AL IQITADAR SCHOOL
UNDER THE COMMANDER'S EMERGENCY RESPONSE PROGRAM ANBAR PROVINCE, IRAQ

SUSTAINMENT ASSESSMENT

SIGIR PA-08-141 JANUARY 26, 2009

SUBJECT: Report on Rebuilding of the Al Iqitadar School in Anbar Province, Iraq (SIGIR Report Number PA-08-141)

Site Photo 7. Uneven floors

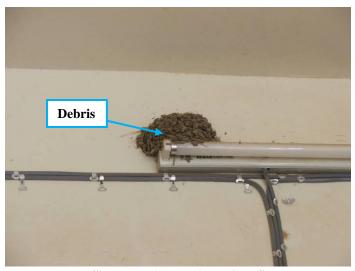
During the site visit, SIGIR observed the construction of the new classroom buildings. The roof tiles appeared to be in good condition throughout the expanse of the roof. There were drainage holes at the roof's edges, which will allow water to drain from the roof. The exterior and interior walls appeared to be adequately repaired/replaced. The majority of the interior tile and concrete floor work was good; however, there were areas of broken tiles and uneven floors (Site Photo 7).
